Minutes of the Active Transportation Advisory Committee Meeting

April 11, 2022, 7:00 p.m.

5.3 Harris Road Underpass - Feedback on Active Transportation Design

Pitt Meadows Road and Rail Improvements Project
Update to Active Transportation Advisory Committee

Cycling direction – one way

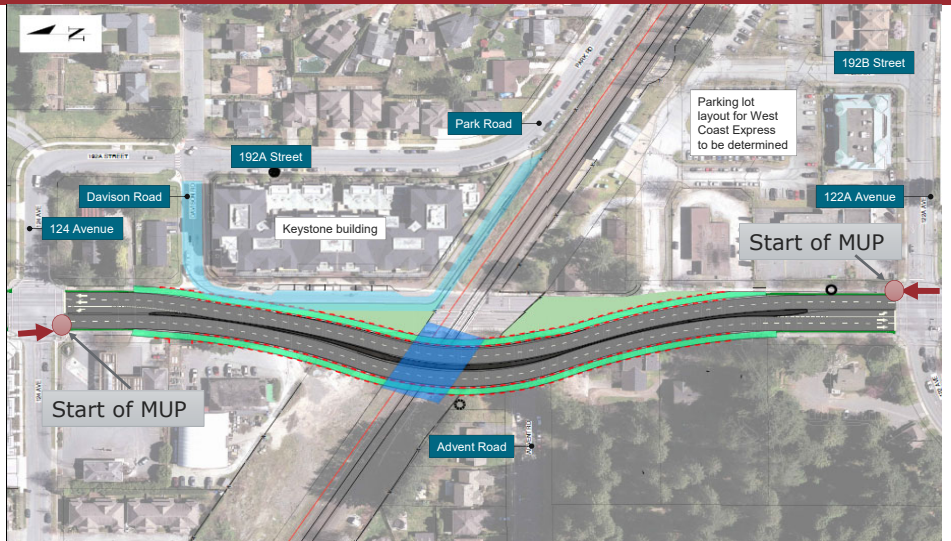
- Support was given for the unidirectional recommendation for cyclists;
- The question was raised if it was recommended people use the Bonson Road overpass to access the West Coast Express since there are no plans for a mid-block crossing (*Staff mentioned that it is unlikely that route would be more convenient for users and that they would likely still use Park Rd to Harris Rd*);

Why is uni-directional proposed?

- Tie into existing conditions
- Reduces conflict points
- Constraints and challenges with contraflow travel if bi-directional
- MUP width constraints
- Increased user safety

Harris Road underpass – Technical cross-section

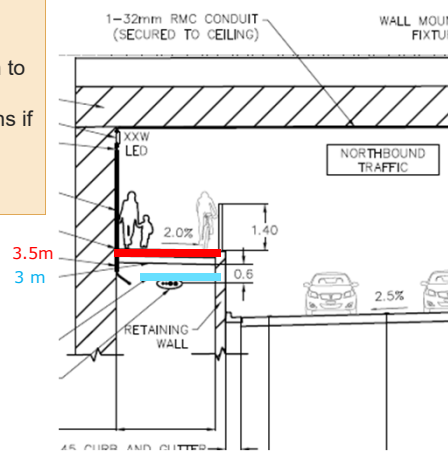
- Discussions were held around the space allocation for pedestrians versus cyclists on the MUP and how it will transition if it is narrowed at the rail portion. There was recommendation to give more space to cyclists;

ATAC preference for consistent bike width throughout MUP.

- What is the right ratio of pedestrian to cyclist space?
- Is there a pinch point for pedestrians if consistent width is maintained ?
- Consideration of mobility aid width when determining minimum ratios
